**METROPOLITAN DEVELOPMENT COMMISSION
REGIONAL CENTER HEARING EXAMINER**

STAFF REPORTS FOR APRIL 28, 2022

STAFF REPORT

REGIONAL CENTER HEARING EXAMINER - HIGH IMPACT CASE

Planting plans

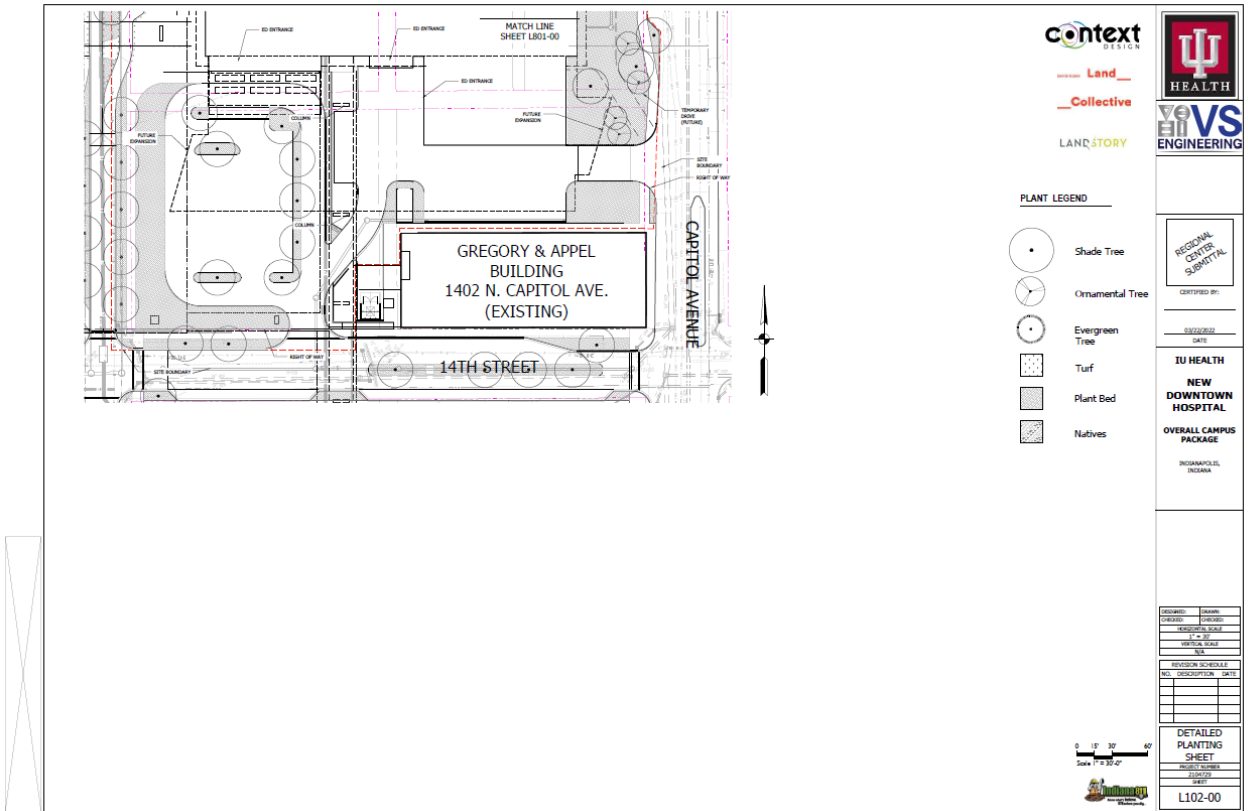
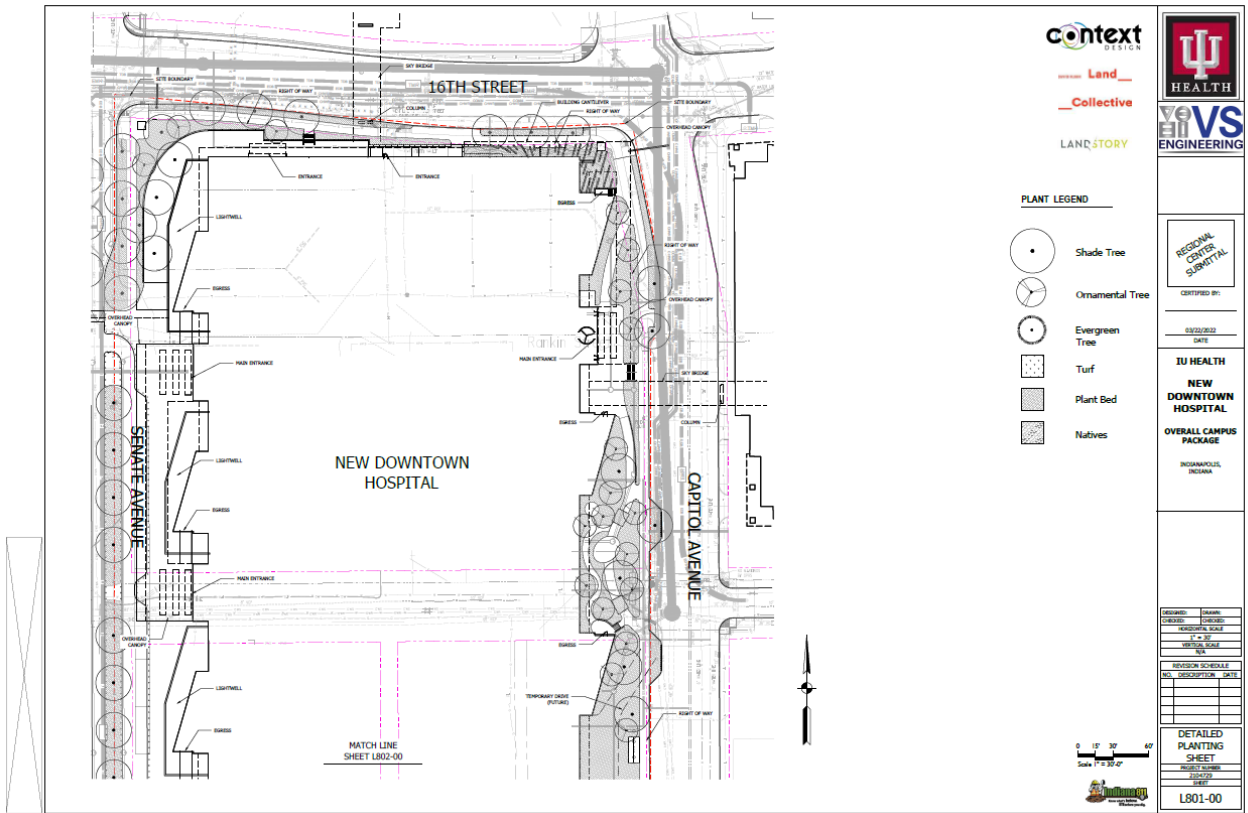
1. A detailed landscape plan, with plant materials has not been submitted to the file. Staff requests that detailed landscaping plan be submitted and subject to planning staff review and approval, prior to installation. (US 1.3.2, CA 4.6.1, CA 4.6.4, CA 4.6.5 and CA 4.6.7)
